# COUNTY OF YORK
## MEMORANDUM

**SUBJECT:** Application No. PD-35-13, Reserve at Williamsburg LLC

This application seeks to amend the conditions of approval for The Reserve at Williamsburg Planned Development by eliminating the requirement for front porches as a condition of reducing the minimum front yard setback requirement from thirty feet (30') to twenty feet (20') for townhouses, duplexes, and single-family detached dwelling units. The Reserve at Williamsburg, located at the intersection of Mooretown Road (Route 603) and Reserve Way, is a 63-acre age-restricted senior housing development with a 7.7-acre commercial center approved by the Board of Supervisors September 5, 2006 through the adoption of Ordinance No. 06-18(R). The property is further identified as Assessor's Parcel Nos. 5-18-1, 5-18-2, 5-18-3, 5-18-4, 5-18-5, 5-18-6 and 5-18-7.

# TOWNHOME LOT EXHIBIT

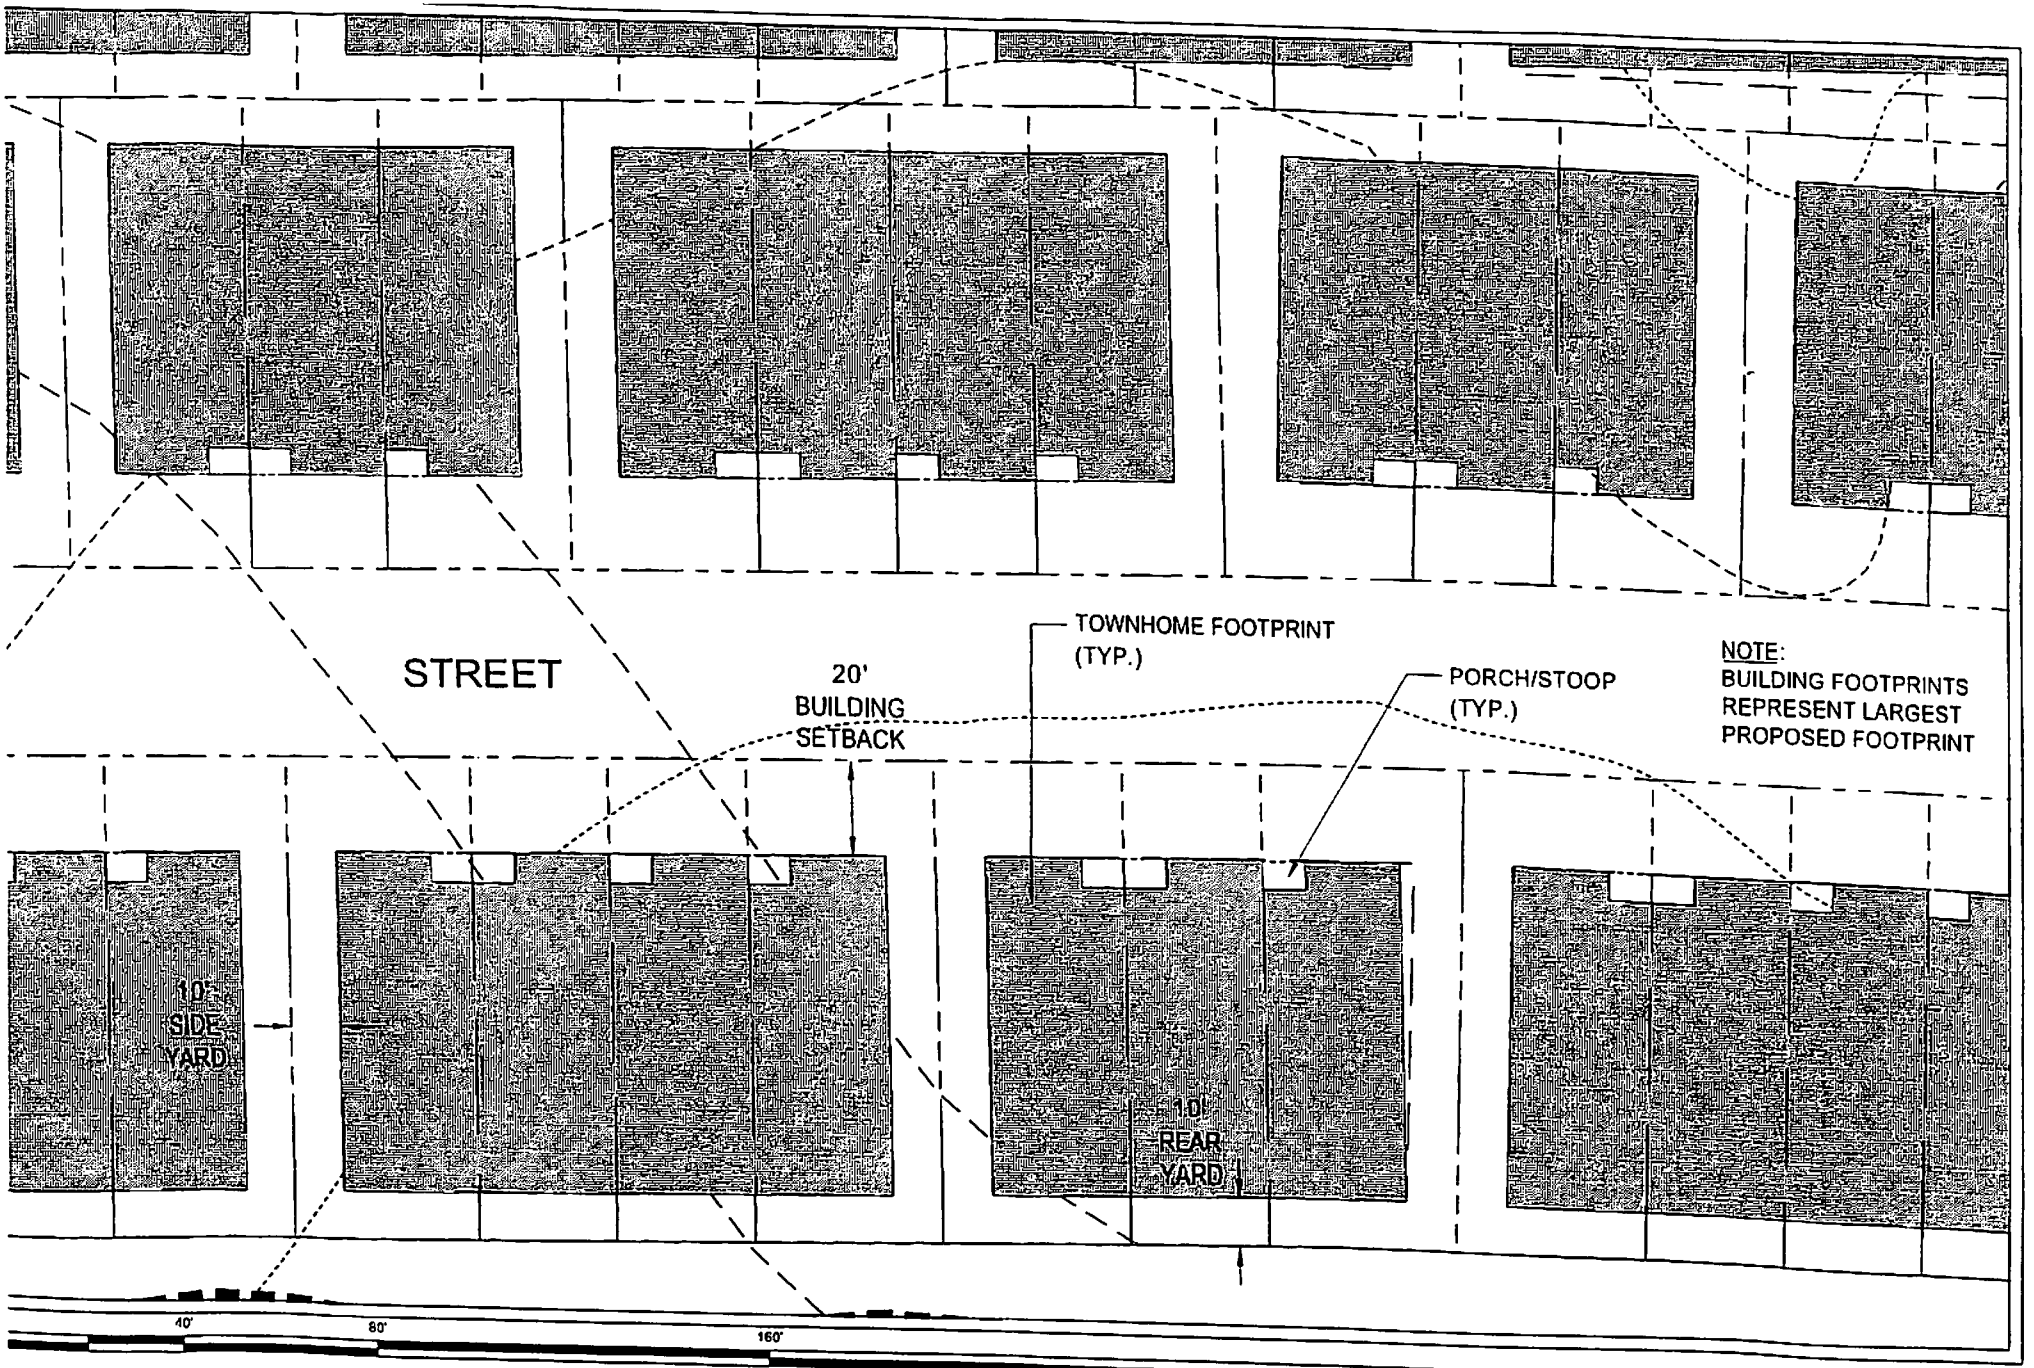
With a minimum building footprint, according to the submitted floor plans, of 27' 6" by 52' 4", the smallest possible townhouse lot size in The Reserve, with the setbacks requested by the developer, would be 2264 square feet – 26% larger than the 1800-square foot minimum lot size in the RMF district. In fact, the "Townhome Lot Exhibit" submitted by the applicant depicts lots that are 100 feet deep with widths ranging from approximately 28 to 40 feet, yielding lot sizes in the 2800 to 4000-square foot range.

Regarding the current request, staff knows of no community design reason to treat townhouses and duplexes in The Reserve differently than other townhouse and duplex developments in the County by requiring the inclusion of front porches in order to qualify for a front yard setback of twenty feet (20'). The lot sizes are comparable to those that would be found in a typical (i.e., general market) townhouse/duplex development, so the need for a greater than normal front yard setback requirement, with or without front porches, is questionable.

# SINGLE FAMILY LOT EXHIBIT

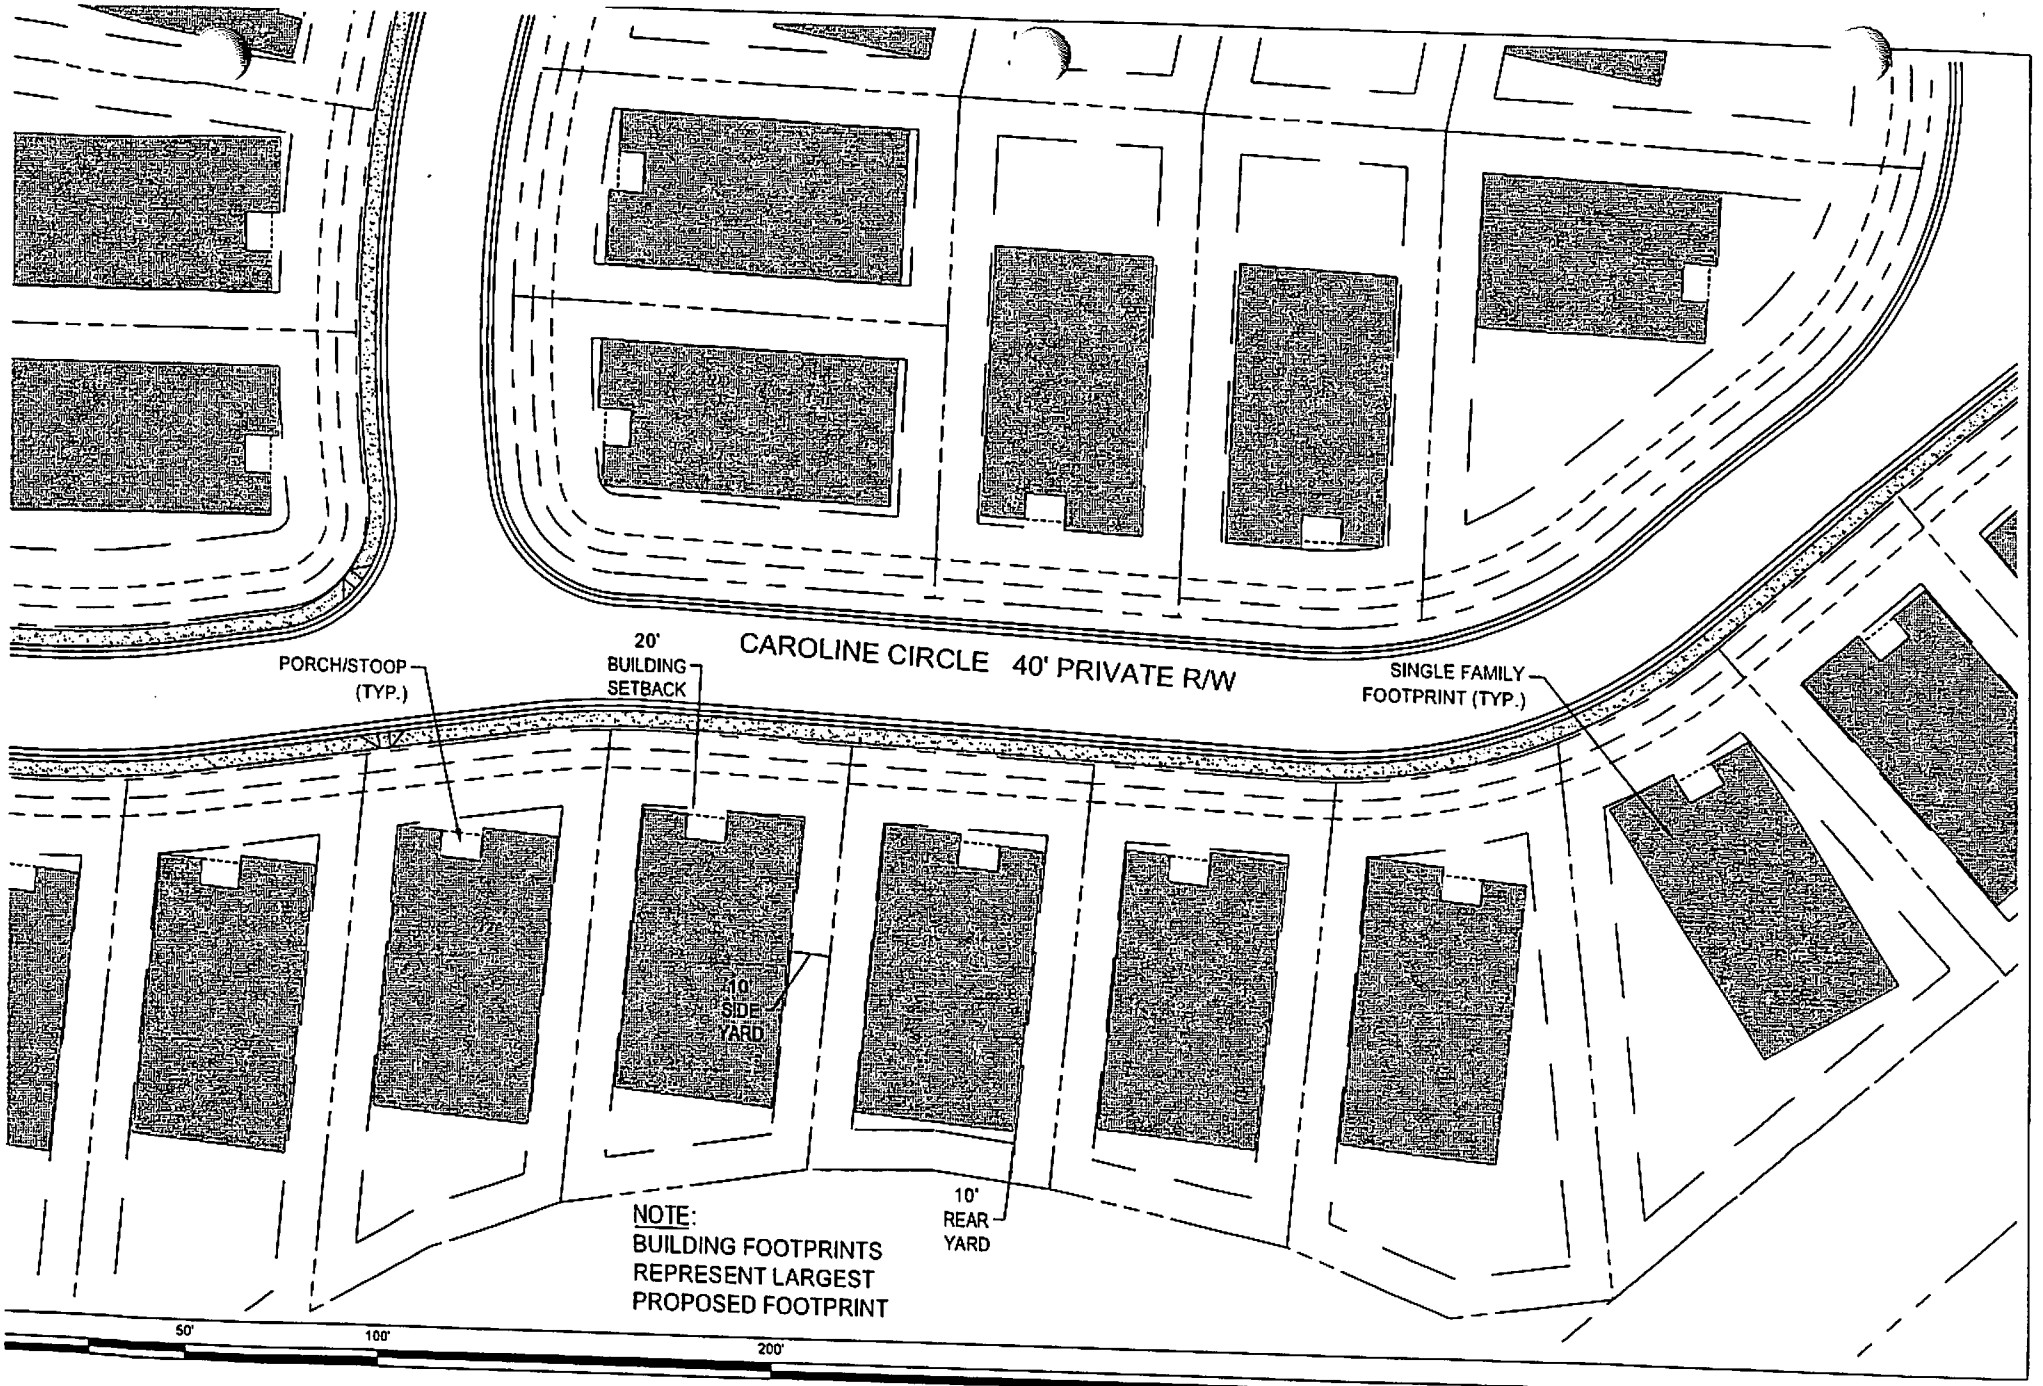
3. Unlike the townhouse lots, the single-family detached lots would be much smaller than in a typical neighborhood, ranging from an estimated 7,000 to 10,000 square feet, according to the "Single Family Lot Exhibit" submitted by the applicant. This is the norm in Planned Developments, as is the thirty-foot (30') front yard setback, although some of the single-family detached sections of Coventry have a front yard setback requirement of 25 feet.

For single-family detached units, however, staff sees no compelling reason to completely eliminate the requirement for front porches where units are set back less than thirty feet (30'). It should be remembered that the question of the reduced front yard building setbacks for single-family detached units was one of several key features of the project about which Board members expressed concerns when this project was originally considered for approval in 2006, causing the application to be tabled to give the applicant an opportunity to make modifications. Ultimately, the setback issue was resolved when the developer agreed to incorporate functional front porches measuring at least 6 feet by 15 feet (90 square feet). The front porches were viewed as a desirable design feature that was consistent with the applicant's expressed desire to create a more traditional, pedestrian-oriented neighborhood atmosphere that would promote interaction among residents. Nothing has changed in the past seven years to alter that view, in staff's opinion. Other than a general weakening in market demand for age-restricted housing (part of a general slump in housing demand), the only apparent change since 2006 is that the houses have become larger than originally envisioned, which, if anything, would tend to weaken the case for reducing the front yard setback. However, staff believes there is room for flexibility in defining what constitutes a "functional" front porch. The current minimum of ninety (90) square feet (6' by 15') – which was not set by the Board but offered by the developer in 2006 – is a fairly substantial porch, and staff believes a reduction to a minimum area of fifty (50) square feet with a minimum depth of four feet (4') is sufficient to achieve both the Board's goals and the developers' goals in terms of creating a pedestrian-oriented neighborhood atmosphere. The developers have indicated that they would be amenable to the revised porch size standards.
